EnergyConnect (NSW – Eastern Section)

Response to Department of Planning and Environment Request for Information

30 August 2022

This memorandum provides responses to various Requests For Information (RFI) raised by the NSW Department of Planning and Environment (DPE) in June, July and August 2022.

Figure 1-8 Photomontage of R501 – 6645 Holbrook Road, Gelston Park

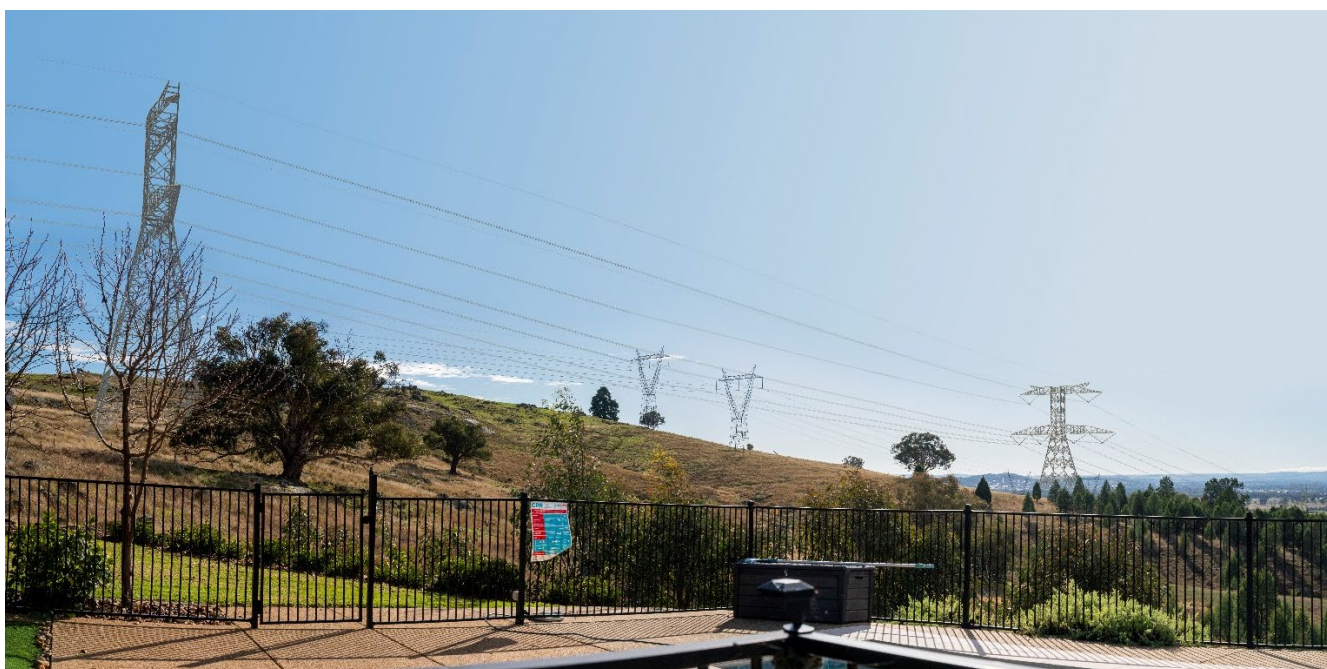
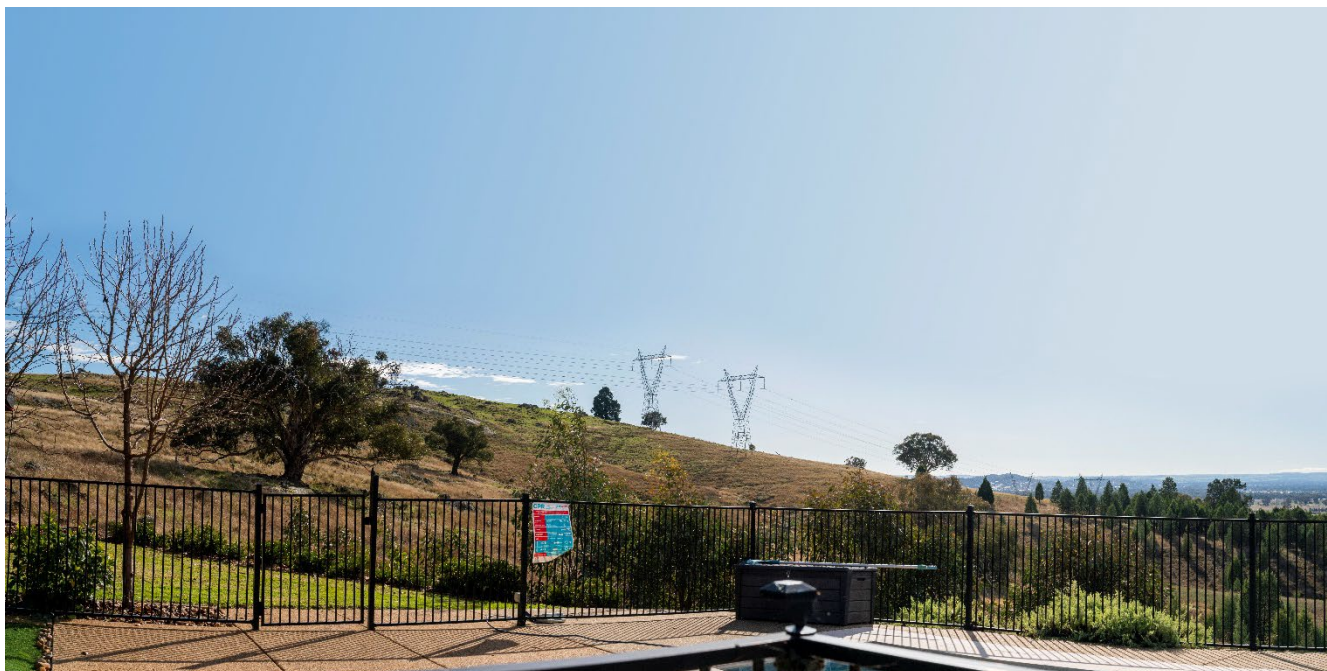
Photomontages from representative locations for the following receivers have been prepared and included as Figure 1-1 to Figure 1-10 below:

Figure 6-12

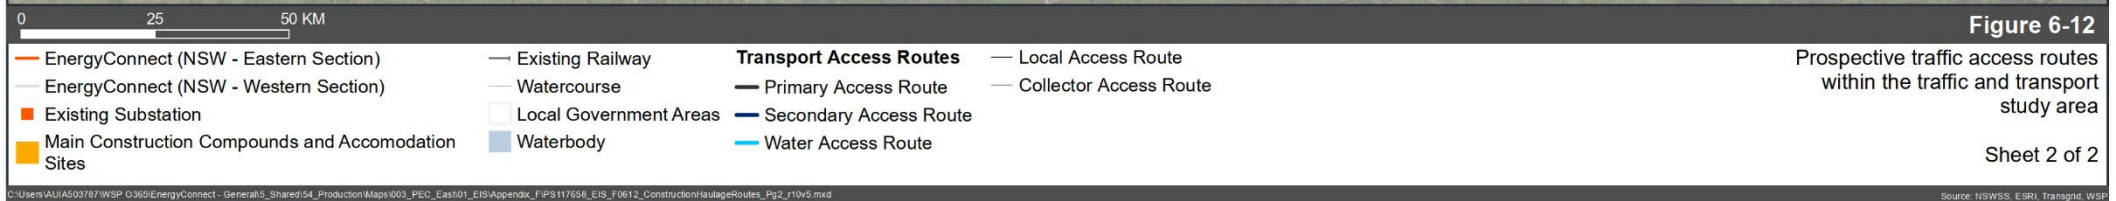
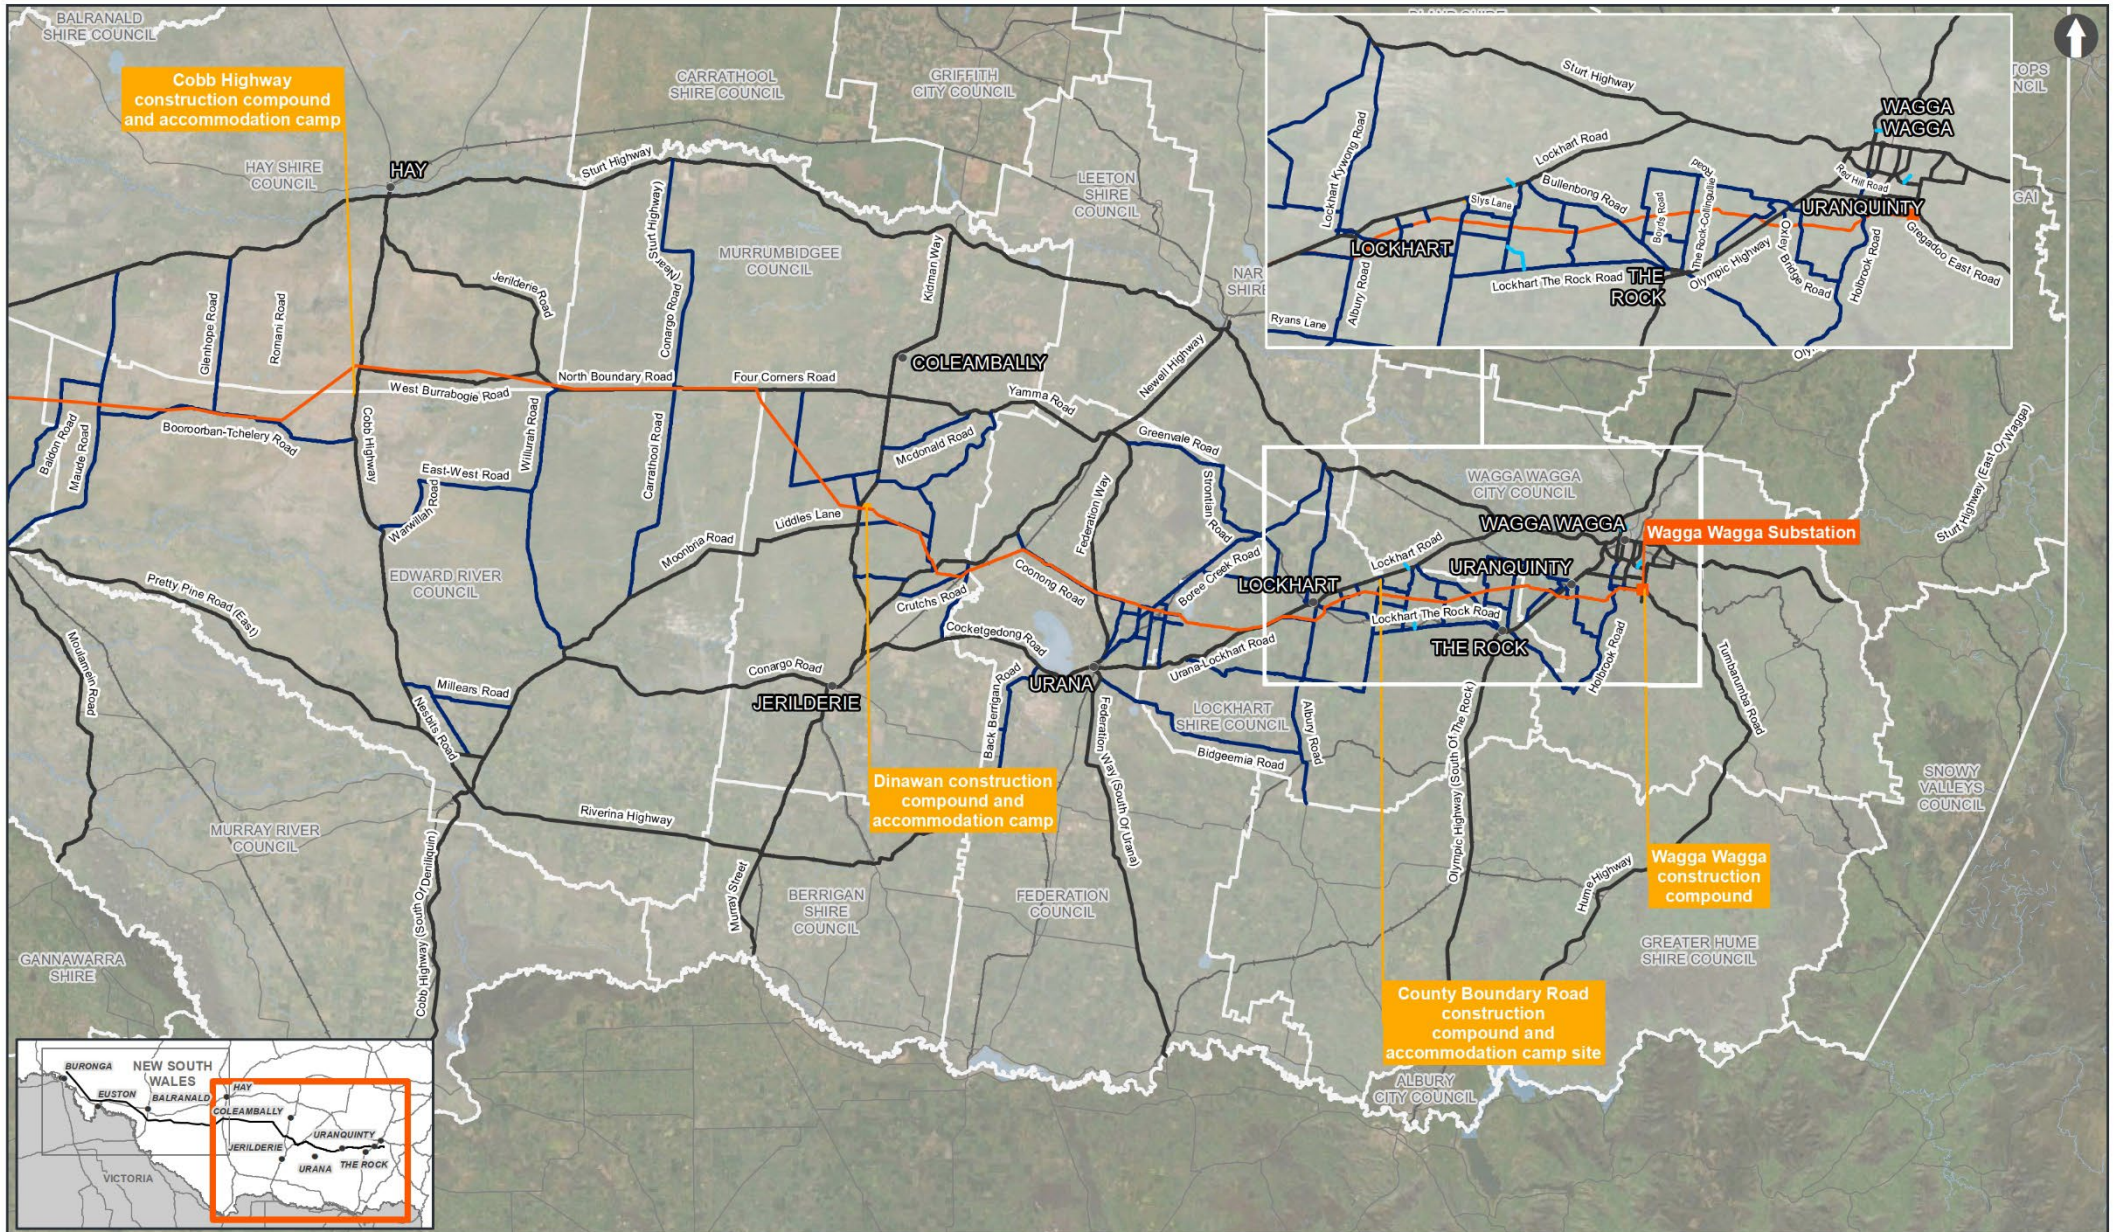
Transgrid has renamed 'haulage routes' as 'access routes' to reflect that these routes will be used by all project-related traffic accessing construction locations, not just heavy vehicles hauling plant and equipment. To account for this change, revised figures for inclusion in Appendix 4 of the project Infrastructure Approval have been provided below.

Figure D-4e

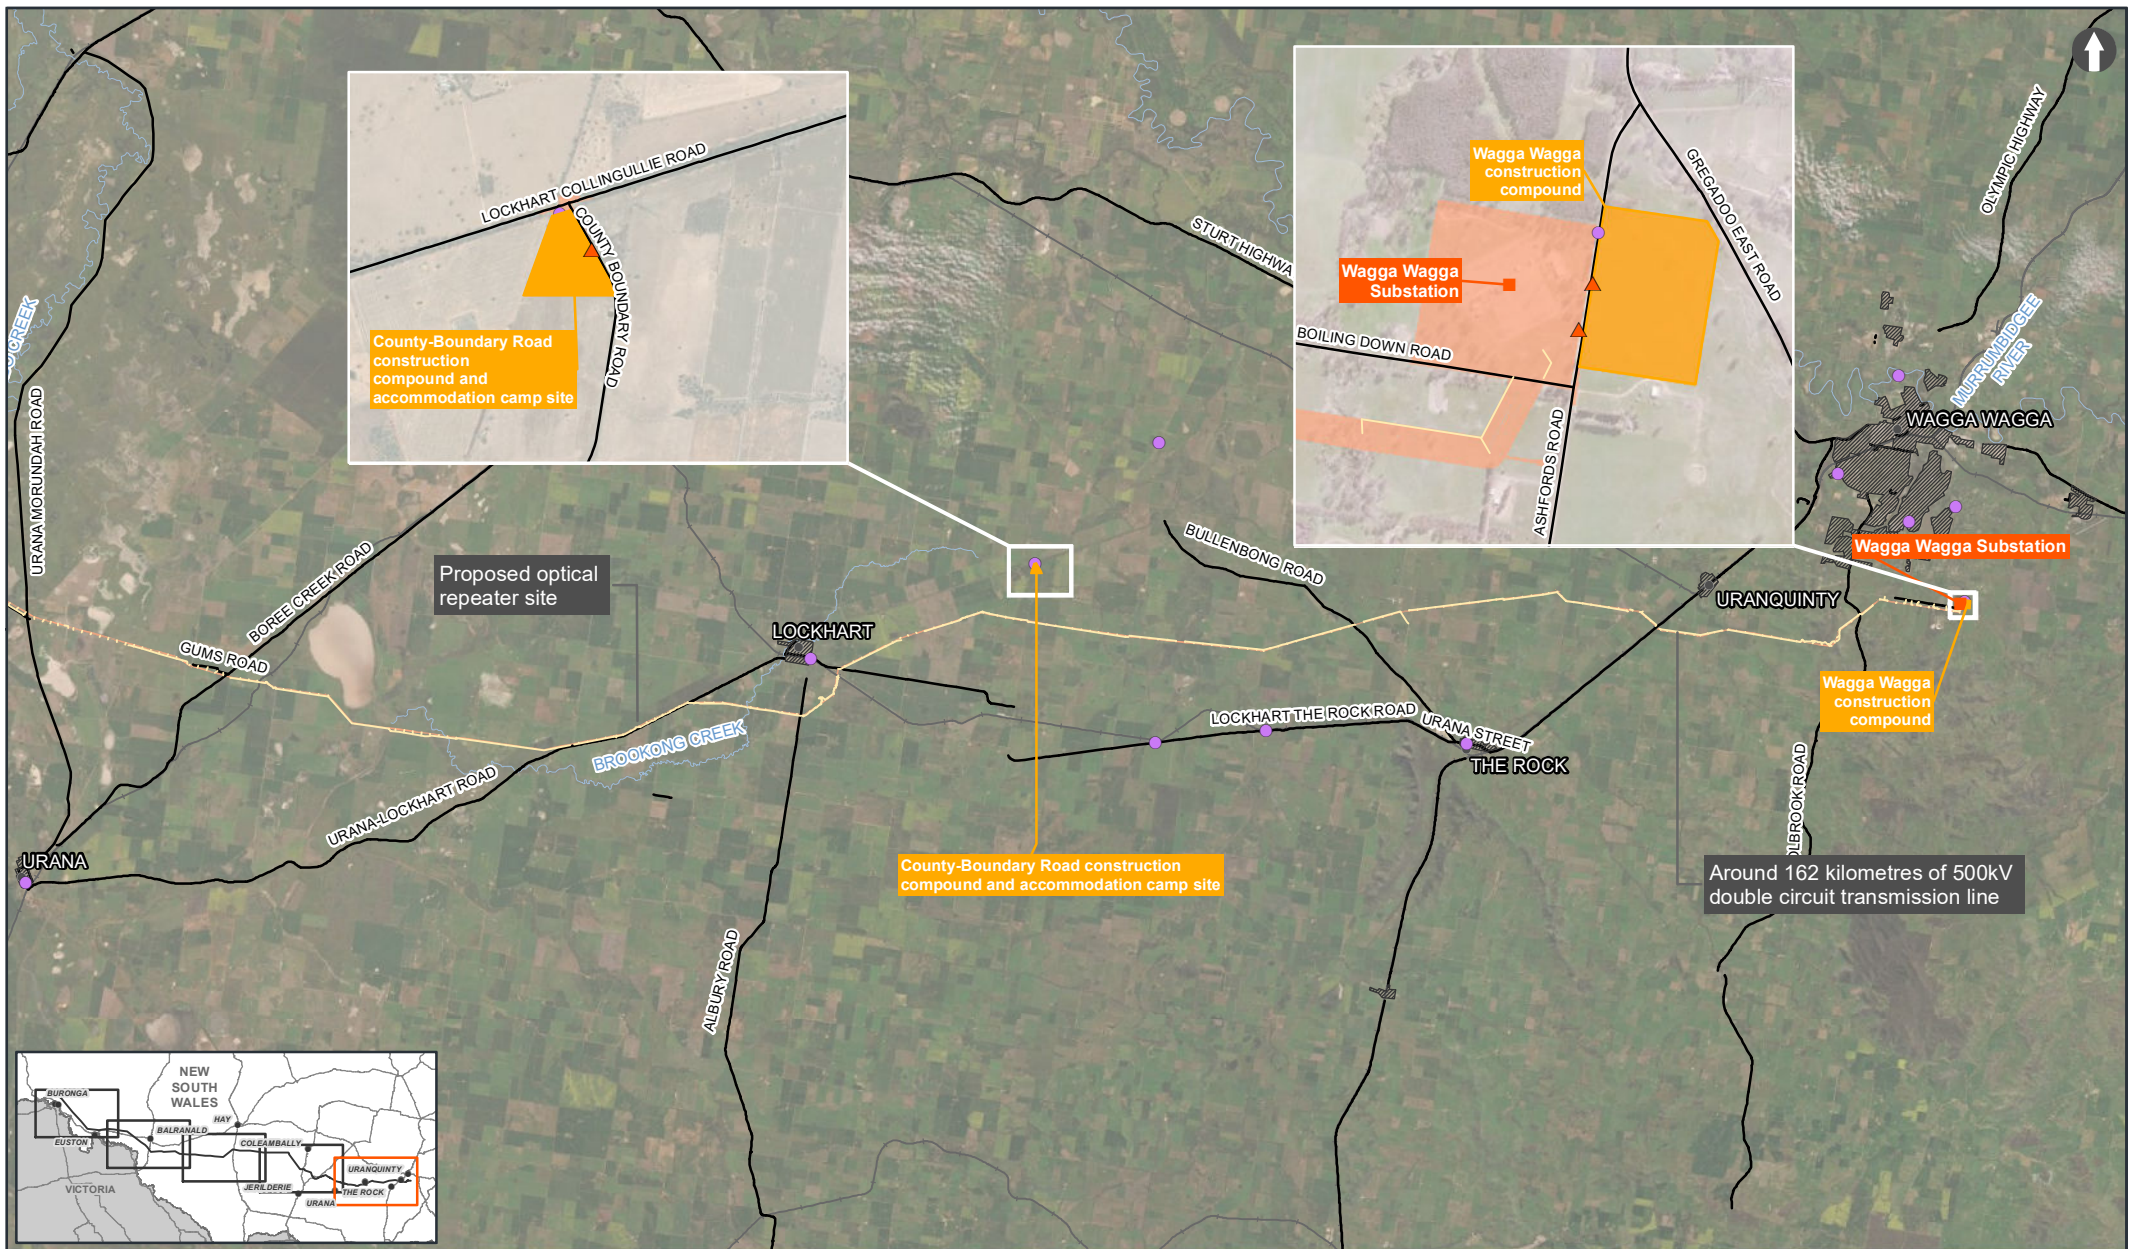
Appendix 3 – Updated Figure D-4e from Submissions Report
